# Staff Summary Report

**SUBJECT:** Hold a public hearing for a Use Permit and Development Plan Review for FEDEX EXPANSION located at 1666 North McClintock Drive.

**COMMENTS:** Request for **FEDEX EXPANSION (PL070460)** consists of a +/- 50,656 s.f. one story addition to an existing +/- 95,215 s.f. one story ground distribution center on +/- 11.16 net acres in the GID, General Industrial District and the RSOD, Rio Salado Overlay District. The request includes the following:

EXISTING BUILDING  
EXTERIOR ELEVATION - EAST

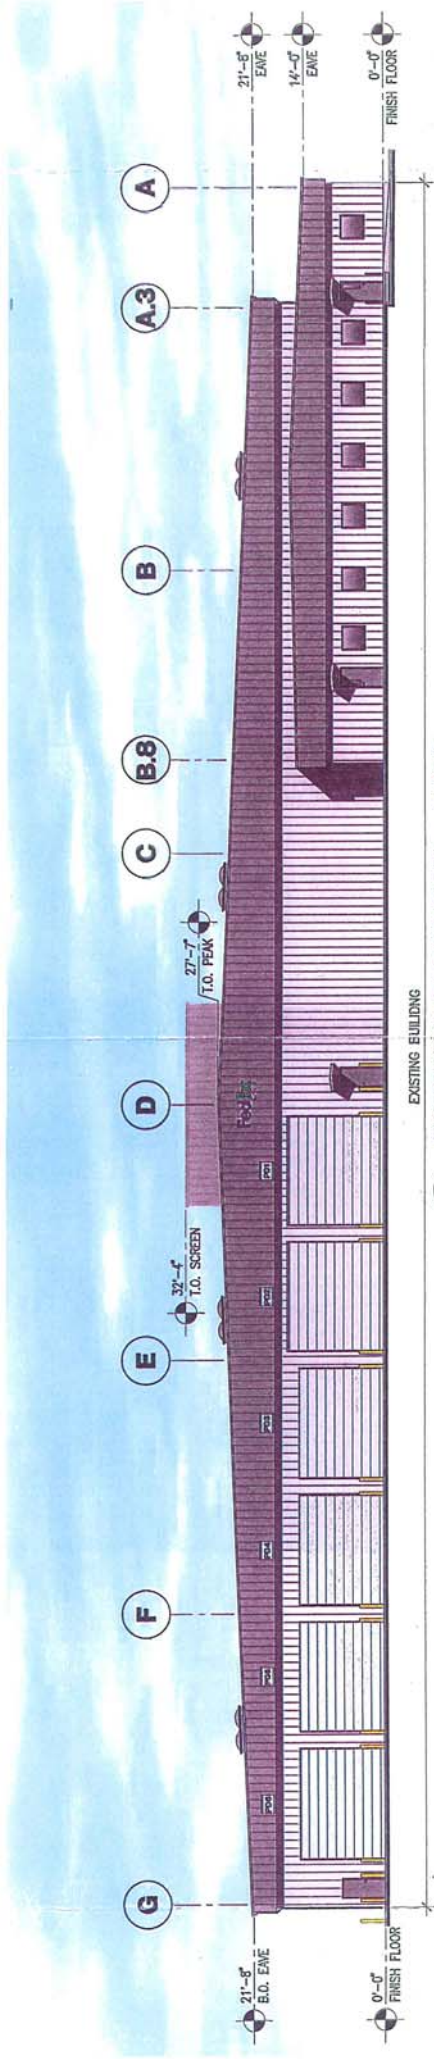
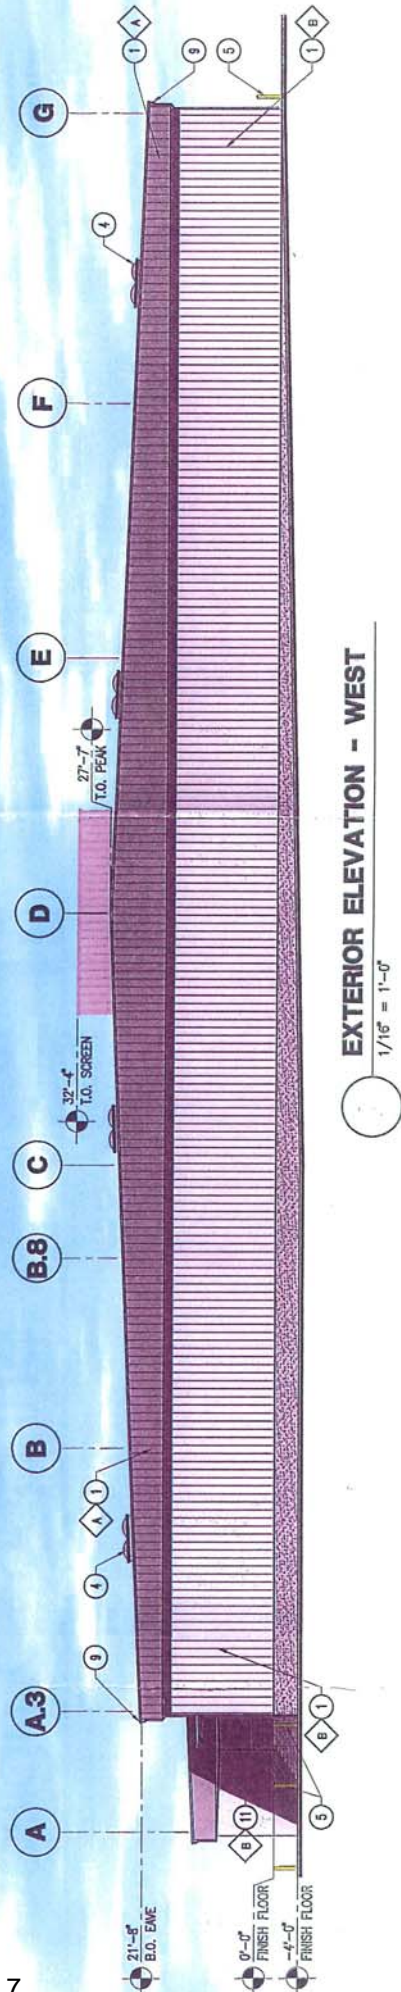
12. Match exhibited colors and materials for the pre-finished metal panels (MBCI 'Ash Gray' and 'Polar White') for the addition to those of the existing building (Galvalume 'Fox Gray' and 'Polar White'). If the manufacturer differ as is indicated, demonstrate the finishes match to Planning staff during the building plan check process.

23. Provide two 0'-12" high address letter signs on the west elevation. Locate signs at uniform height. Conform to the following for address signs described in this condition:
  - a. Direct- illuminate the signs, similar to the existing building.
  - b. Provide street number.
  - c. Compose of individual mount, metal reverse pan channel characters. Match existing building detail.
  - d. Coordinate locations so signs are unobstructed by trees.

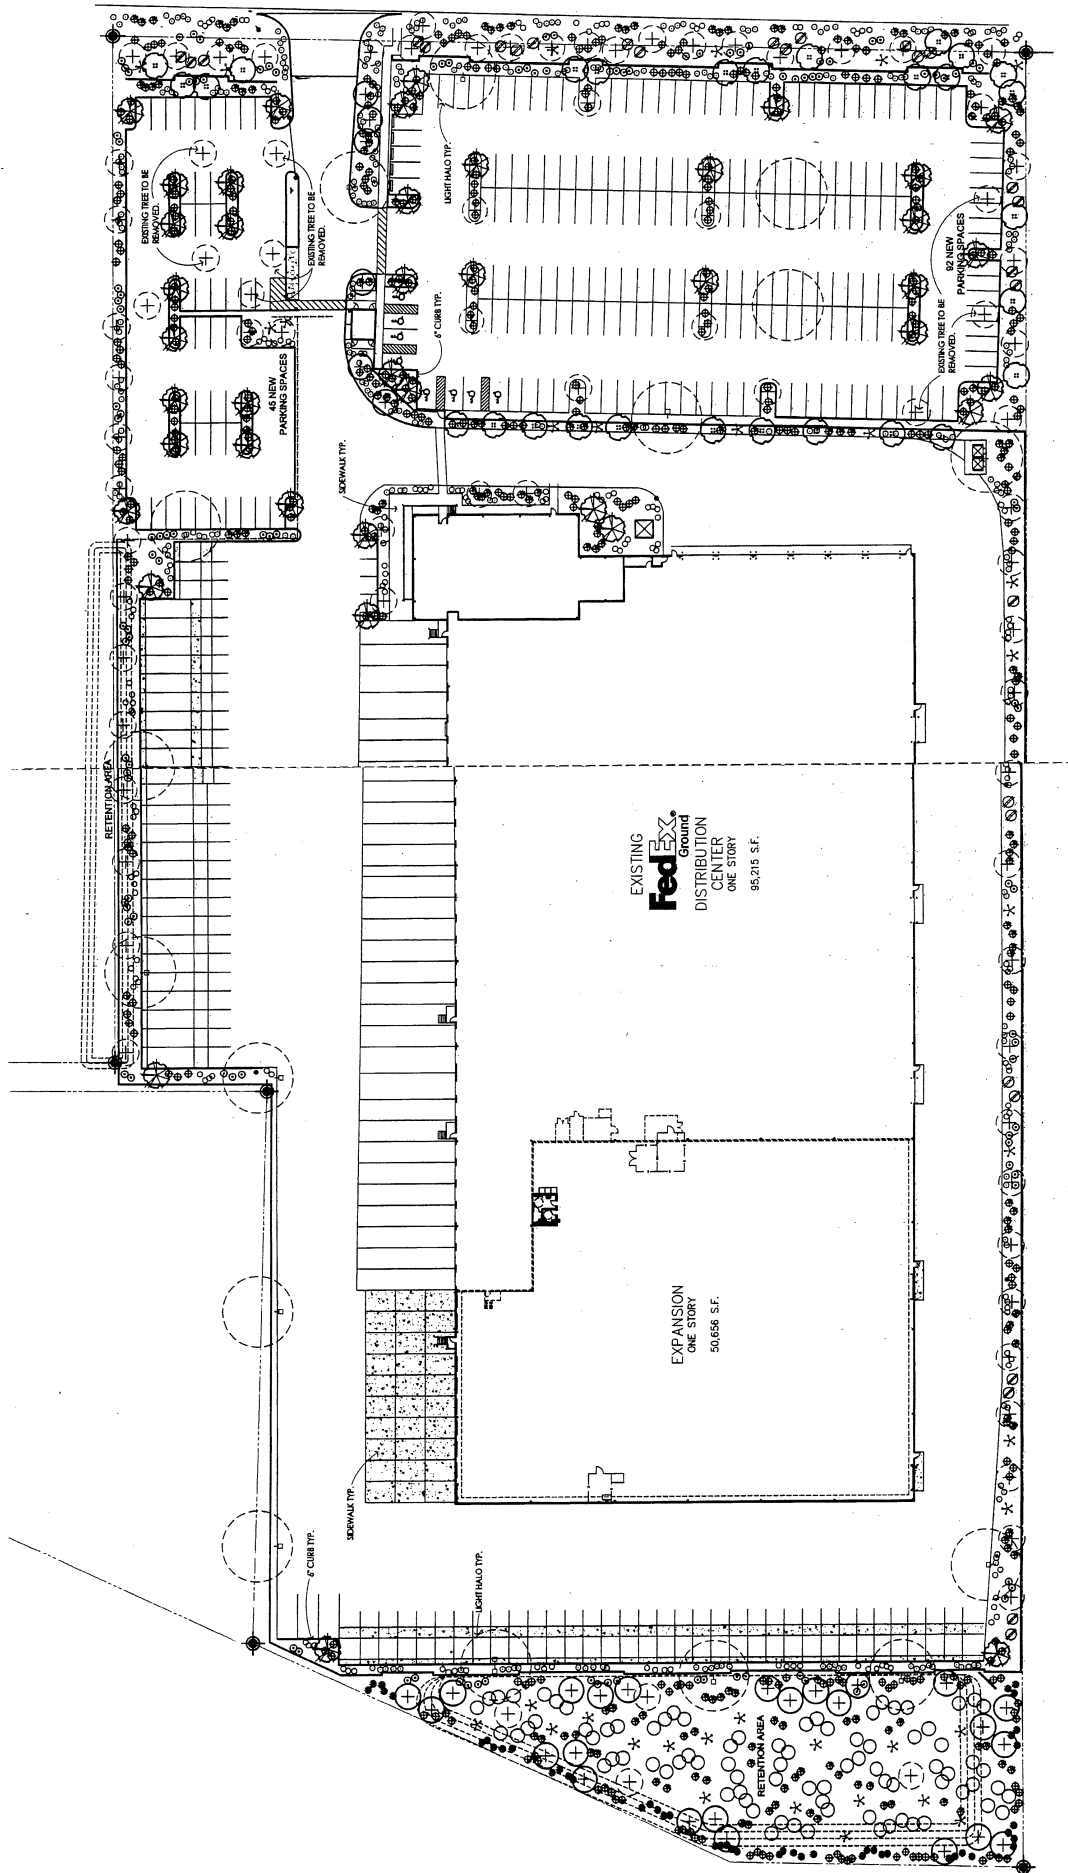
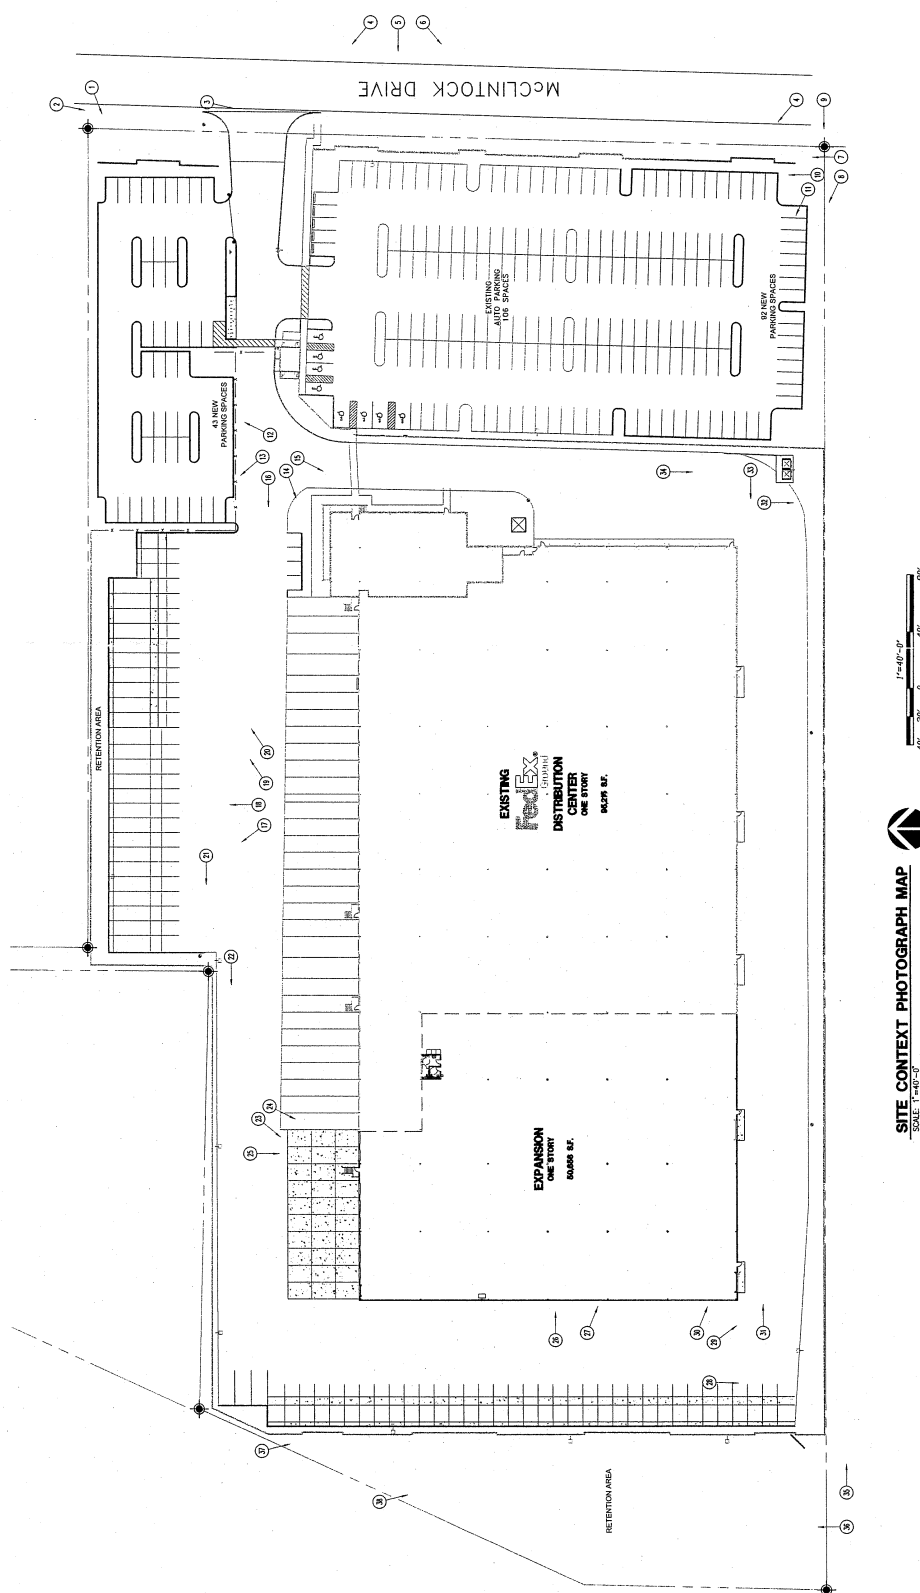
- c. Tree buffers do not need to be in a line but may undulate to avoid physical features and provide security light clearances.
3. Preserve four existing trees that are indicated on sheet L-2 to be removed. Provide parking landscape islands of at least 120 s.f. area for each of these trees. If site grading prevents the maintenance of these trees in place due to the disparity between finish and natural grade, replace these trees with like specimens of minimum 24" box installation in the locations indicated:

18. Indicate existing landscape to remain and identify by species. Make provision in the landscape documents to protect and maintain the existing, remaining landscape during construction. Prune existing trees, treat for insects and disease, and guy for upright growth as required. Where an existing tree indicated to remain dies or shows probability of dying, replace with a specimen of minimum 24" box size at installation. Provide replacement plants of minimum 5 gallon size at installation. Replacement trees and plants may match existing in species or may be an approved alternate.
19. Provide three Dalbergia Sissoo in the large landscape island north of the main entrance drive and immediately east of the bicycle parking.
